Title: PROPOSED ORDINANCE 21-18 - AN ORDINANCE CREATING SECTION 12-2-25 OF THE CODE OF THE CITY OF PENSACOLA, PROVIDING FOR THE CRA URBAN DESIGN OVERLAY DISTRICT

LEGISLATIVE ACTION ITEM

PROPOSED ORDINANCE 21-18 - AN ORDINANCE CREATING SECTION 12-2-25 OF THE CODE OF THE CITY OF PENSACOLA, PROVIDING FOR THE CRA URBAN DESIGN OVERLAY DISTRICT

Table 12-2-25.3 -Single Family Detached and Two-Family Attached (Duplex) Residential Building Types- R-1AAA through R-1A

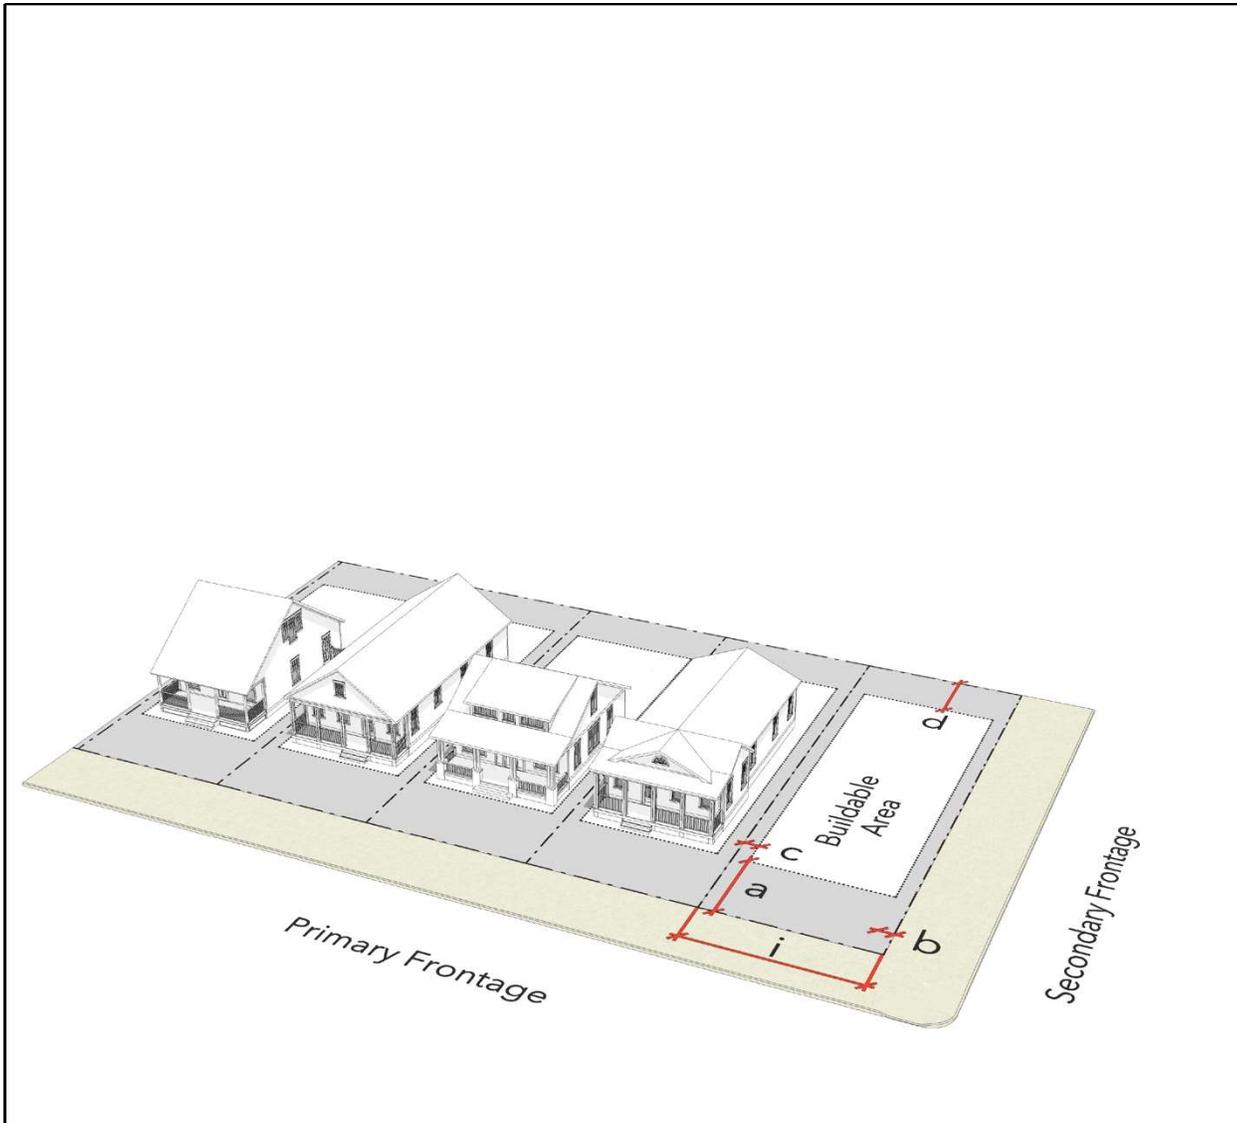
- c. Side and rear setbacks for single family detached and duplex developments on thirty-foot (30') lots should be reduced as follows:
 - a. Side setback reduction from five (5) feet to three (3) feet for single family detached and duplex buildings (Tables 12-2-25.3 and 12-2-25.4).
 - b. Rear setback reduction from 25-30' to 20' for single family detached and duplex buildings (Tables 12-2-25.3 and 12-2-25.4).

- (1) Measured according to Section 12-2-25(G)(a)(c).
- (2) See Section 12-2-25(G)(h)(b) for exceptions.
- (3) Lot width shall only be measured from the right-of-way line. Lot width at the building setback
- (4) [Minimum side yard setback for thirty-foot \(30'\) lots shall be three \(3\) feet measured from the required per applicable Florida Building Code.](#)
